# Access Compliance Report

## Public Rights-of-Way

### (Curb Ramps)

Intersection ID: 52441	Main Street: WOODWARD_AV	Cross Street: BENDING_BIRCH_PL	Location: SE
ADA ID: 748C95C156D9	Ramp Type: Perp	Initial Pass/Fail: Pass	Overall Compliance: No
Severity Score: 30.25			
Codes/Mitigation Info/Possible Solution		Field Measurements/Component Compliance

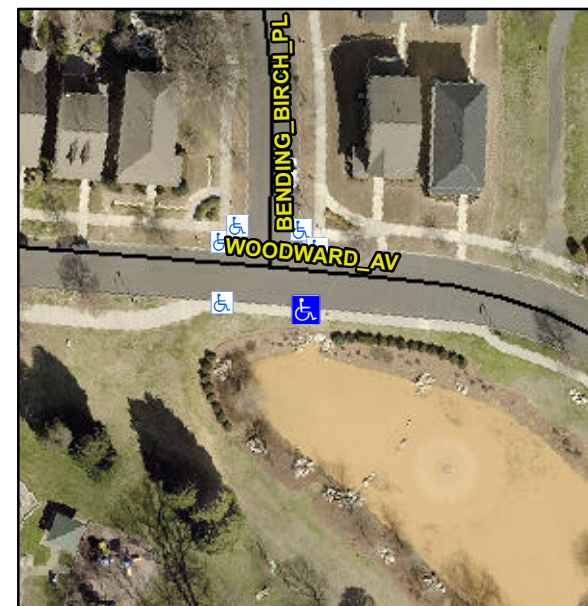
**R304.5.3, R304.2.1, R304.2.2-Perp,  
R304.3.2-Para, R302.7.2, R304.5.4**

Compliance	Description	Data	Compliance	Description	Data
N/A	Ramp Length (in)	60.5	Yes	Ramp Slope (%)	7.7
Yes	Ramp Width (in)	72.0	No	Ramp XSlope (%)	2.4
N/A	Flare Type LT	Sloped	N/A	Flare Type RT	N/A
N/A	Flare Slope LT (%)	10.2	N/A	Flare Slope RT (%)	3.9
N/A	Flare Traversable LT?	No	N/A	Flare Traversable RT?	No
No	Landing Length (in)	N/A	Yes	DWS Provided?	Yes
No	Landing Width (in)	N/A	Yes	DWS Contrast?	Yes
No	Landing Slope (%)	N/A	Yes	DWS Length (in)	24.0
No	Landing X Slope (%)	N/A	Yes	DWS Full Width?	Yes
N/A	Landing Curb? (Y/N)	No	Yes	DWS Offset (in)	0.0
N/A	Shared Landing?	No			
Yes	Gutter Ponding?	No	No	Gutter Slope (%)	6.5
No	Gutter Lip Ht (in)	1.0	Yes	Gutter X Slope (%)	2.2
N/A	Painted X Walk1?	No	N/A	Painted X Walk2?	N/A
	X Walk 1 Direction	To N		X Walk 2 Direction	N/A
N/A	X Walk 1 Width (in)	N/A	N/A	X Walk 2 Width (in)	N/A
	X Walk 1 Slope (%)	4.5		X Walk 2 Slope (%)	N/A
	X Walk 1 X Slope (%)	2.2		X Walk 2 X Slope (%)	N/A

**Remove & Replace Entire Ramp.  
Remove & Replace Gutter.**
